SUBJECT: REQUEST FOR ADDITIONAL INFORMATION REGARDING POST-FIRE
SAFE SHUTDOWN CAPABILITY

SEABROOK STATION UNITS 1 AND 2
REQUEST FOR ADDITIONAL INFORMATION
CONCERNING POST-FIRE SAFE SHUTDOWN
AUXILIARY SYSTEMS BRANCH

FIGURE 1: MULTIPLE HIGH IMPEDENCE FAULTS

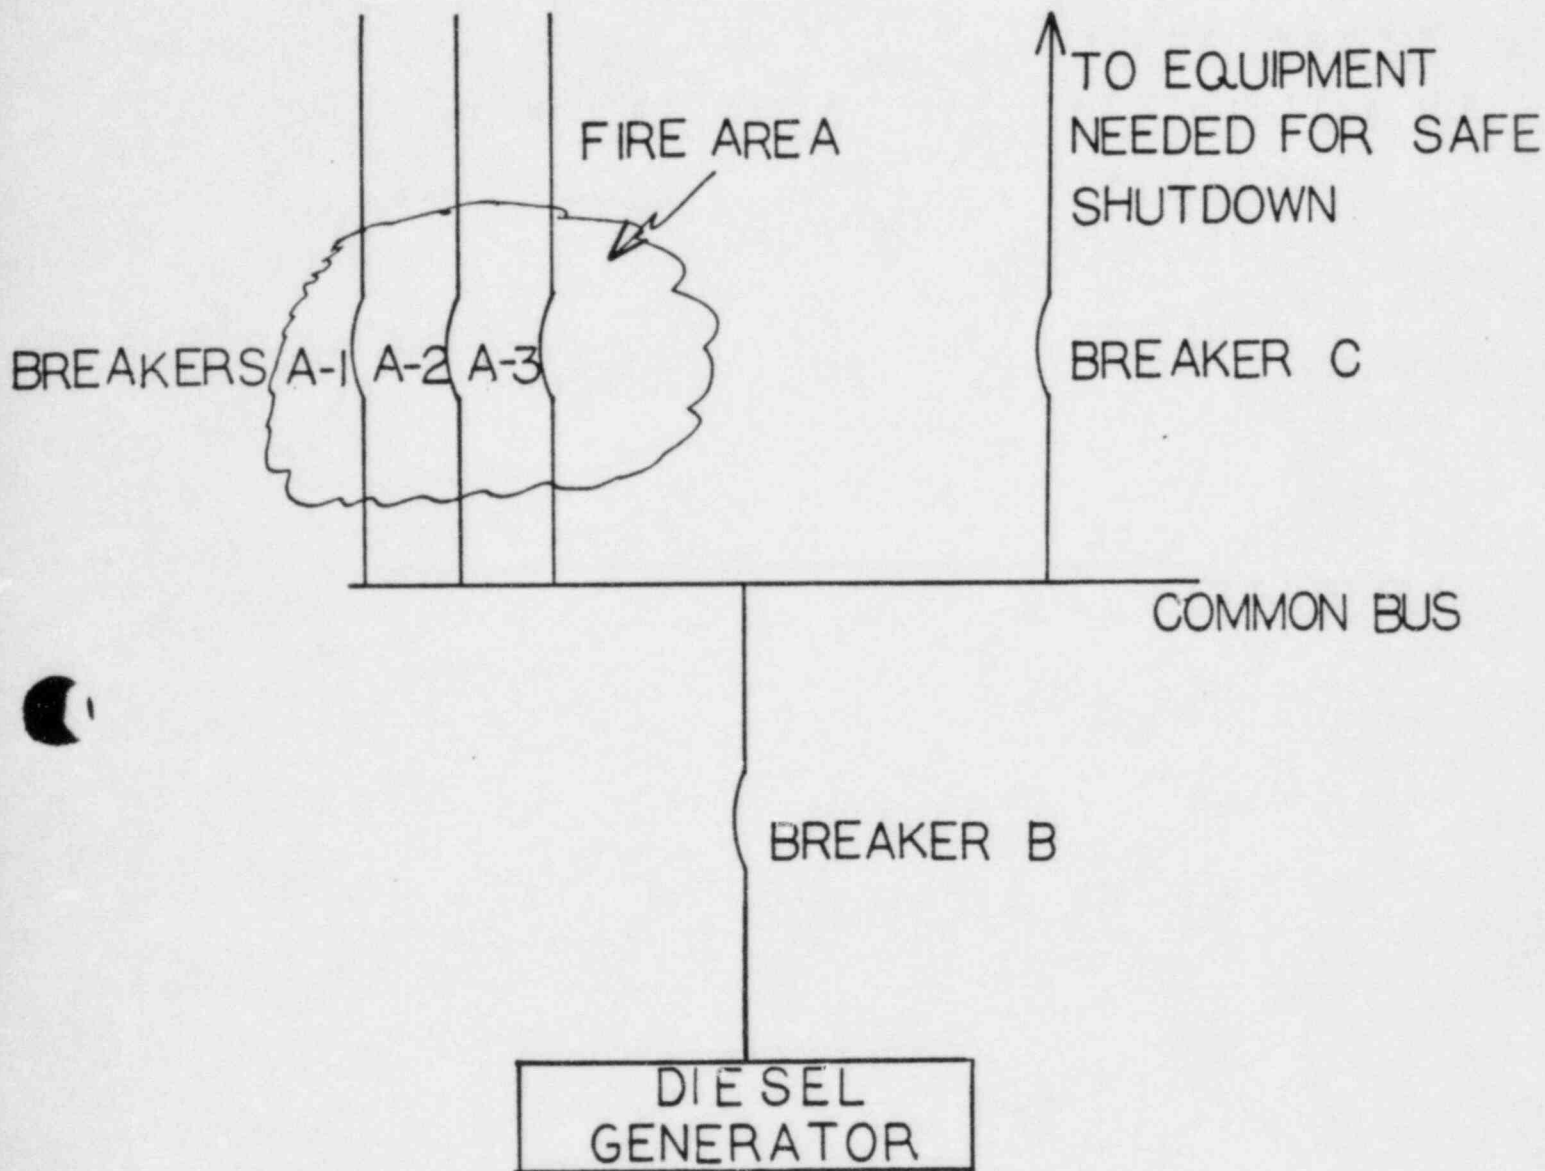
410.58 We have a concern regarding the potential for multi-high impedance faults in AC power circuits which could result in the loss of power to safe shutdown equipment. Figure 1 contains a sketch of circuit designs which could result in the loss of needed power to safe shutdown equipment. As can be seen in Figure 1, redundant divisions of safe shutdown cables are properly separated in accordance with Appendix R criteria. However, a fire in fire area A would result in loss of Division A safe shutdown equipment and cause damage to nonsafe shutdown cables associated with the Division B bus. Further, the individual fault current resulting from the fire damage in the nonsafe shutdown cables may not be enough to trip the individual breakers (B_1 and B_2), but the sum of the faults may be sufficient to trip the main breaker, B_3 . If this were to occur, the Division B bus and the corresponding redundant Division B safe shutdown would be lost. You must show that multi-high impedance faults in AC power circuits resulting from a single fire cannot result in the loss of function of any safety-related system as outlined above.
